## Product Change Notification

**PCN No:** 2006-12-07-01

**Subject:** GLK12232-25-SM PCB 1.4 I2C Changes

**Figure 1: GLK12232-25-SM PCB 1.4 I2C changes**

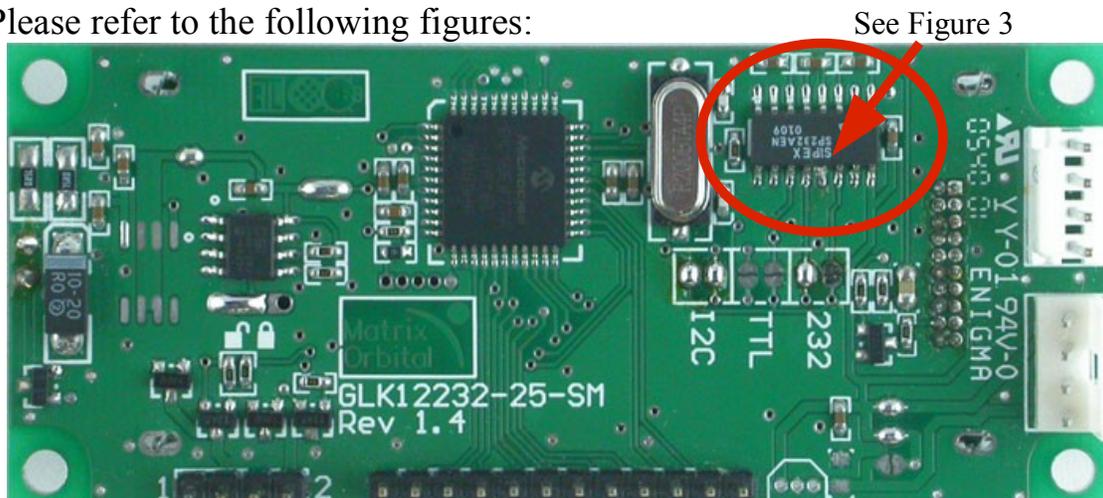
- 1) Solder both I2C pads (2 pads)
- 2) Solder left 232 pad (1 pad)
- 3) Lift pin 13 of the SP232AEN IC – pin 13 is counted from top right counter clockwise as Figure 1 indicates (please note the board's orientation)
